Jordan Mealey

SUPPLEMENTARY REPORT ON FLOOD IMPACTS OF FILLING ADDITIONAL LAND ADJACENT TO ALBION PARK AIRPORT for Delmo Pty. Ltd.

From the Shellharbour City Council, Draft Letter for Council's Consideration Submission on Environmental Assessment Exhibition the following questions were asked:

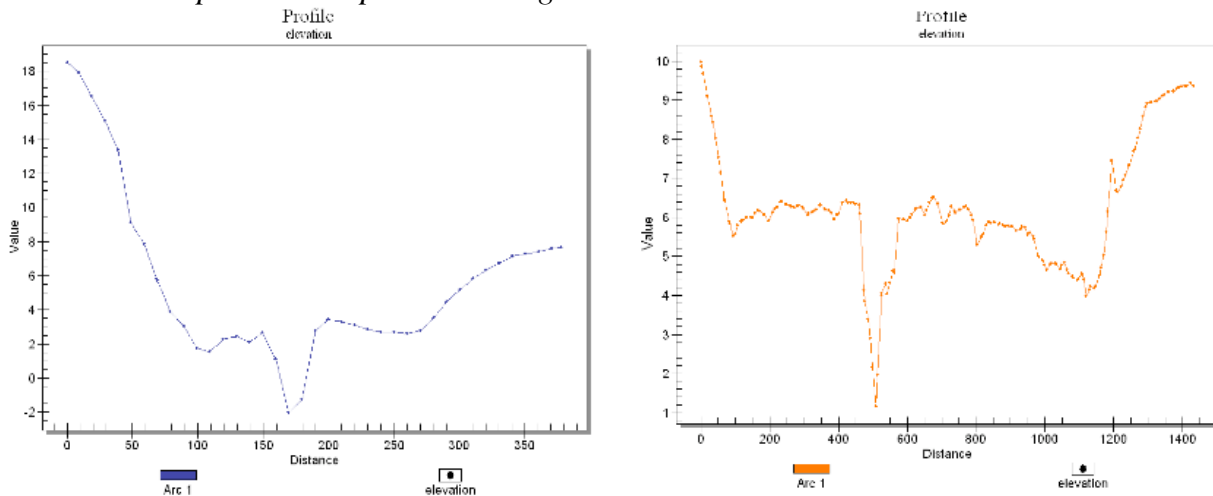
What is a reasonable estimate to the probable impact of further filling of the flood plain?

We carried out an investigation of the area surrounding the floodplain to determine areas of future filling, only one other area could be considered for filling. The area considered was the Western side of Croome Lane. This area has been the subject of a previous DA where residential development was considered this old DA did not proceed due to economic reasons and this had minimal impact on the flood levels.

We investigated the impact of filling land on the western side of Croome Lane on flood levels in 1% AEP and PMF flood events. In this (1D) scenario, an earthworks platform 100m wide has been created within the properties along the western side of Croome Lane with the outer (western) boundary of the platform at a minimum of RL 6.5m AHD (viz at the level of a 1% flood) and with a minimum crest level of RL 7.0m AHD running parallel to the lane about midway across the site. In reality this has mostly resulted in filling a naturally low area (sag) in property near the southern end of Croome Lane, aligned with the low point in the adjacent runway. As such these earthworks have not significantly increased filling on the floodplain below the 1% flood level and should not therefore be expected to significantly impact levels generally across the floodplain. As discussed, it is however one of the few locations in the floodplain where (despite the presence of serious risk in a PMF flood event) future development might be proposed. Contours of the modified surface in this area are reproduced in Appendix E attached.

The impacts of this additional development on flood levels associated with the proposed (1B) development scheme are shown in Appendix F attached for a PMF event. It is noted that no significant (less than 5mm) impact on flood levels was created anywhere by the modelled fill platform in a 100YR ARI event. This is, as previously noted, to be expected as most of the fill in the fill platform was added above the 1% flood level.

In a PMF event however, filling the sag in the fill platform increases flood levels locally in the vicinity of the sag, reaching a maximum of about 200mm at the western platform crest, dissipating across the runway to disappear altogether about 150m east of the runway. There is however no associated increase in flood level on the floodplain generally as a consequence of the addition of the Croome platform to the 1B scenario. While this scenario has been modelled as one possible additional floodplain fill scenario, development of the Croome site would, present some serious evacuation difficulties and does not therefore seem a very probable future development.
